**UNIVERSITY OF CALIFORNIA, RIVERSIDE**

**PARKING STRUCTURE 1**

**Final Initial Study/Mitigated Negative Declaration**

## Section 2.0 Public Comment Letters and University Responses

H-3

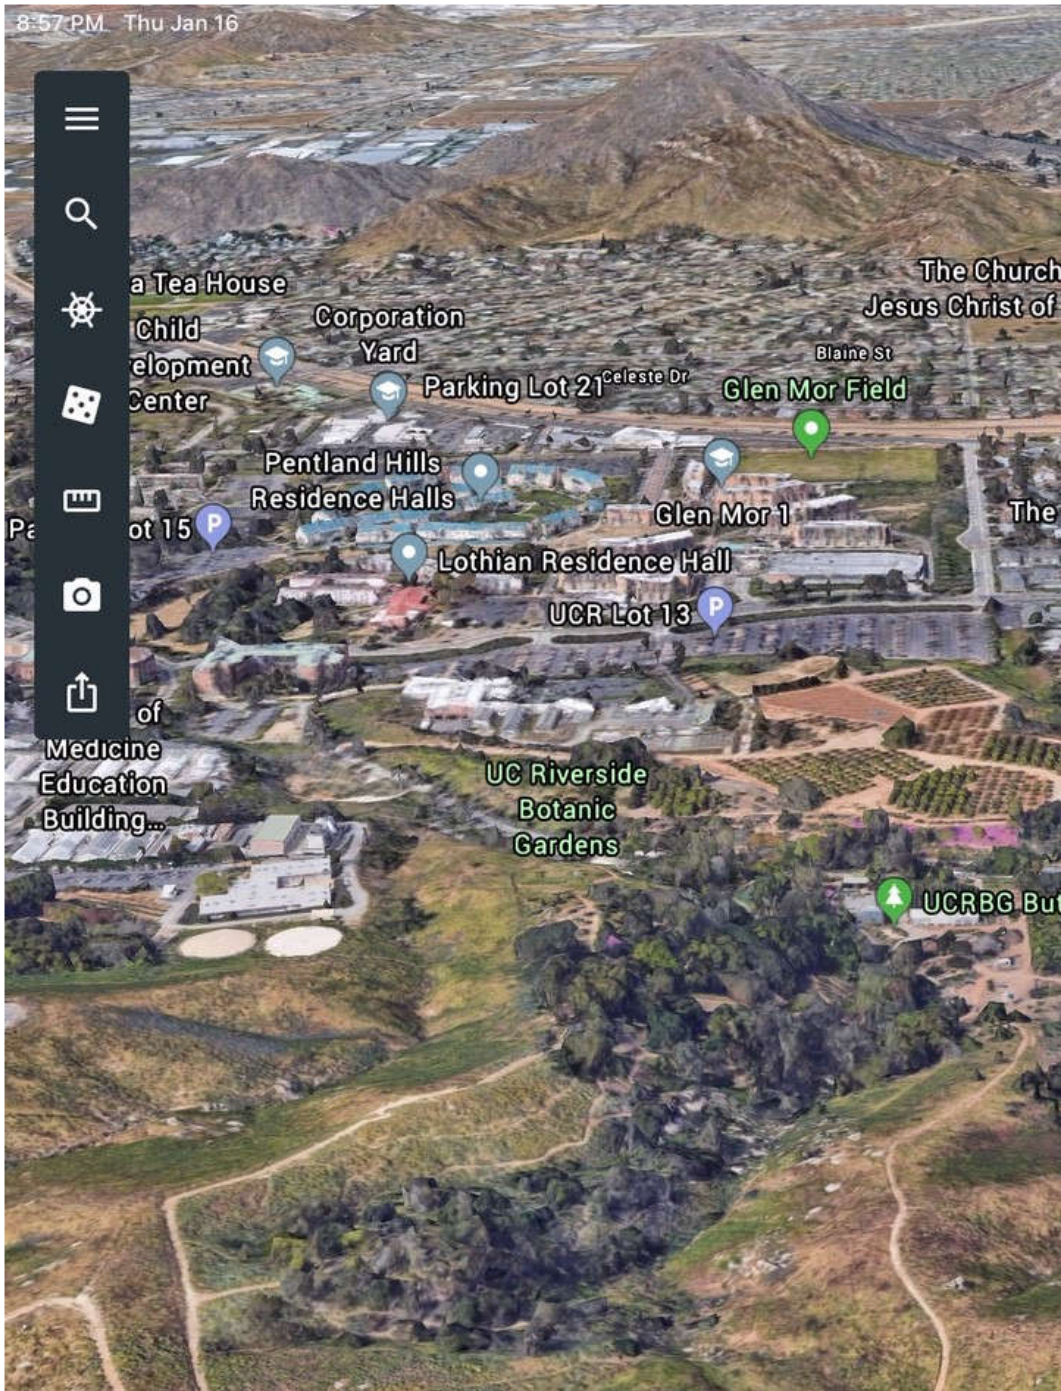
3. The project blocks a wildlife corridor that runs going north of Coyote Hill, along the eastern property line of the campus, through the Botanic Gardens and campus research groves, across the open parking lot, north up Valencia Hills Drive, connecting to the arroyo/blue line stream between Glen Mor 1 & 2, and then up to the Metrolink right of way.

Bobcat, foxes, burros, raccoon, possum, deer, and more, have been observed traversing this wildlife corridor.
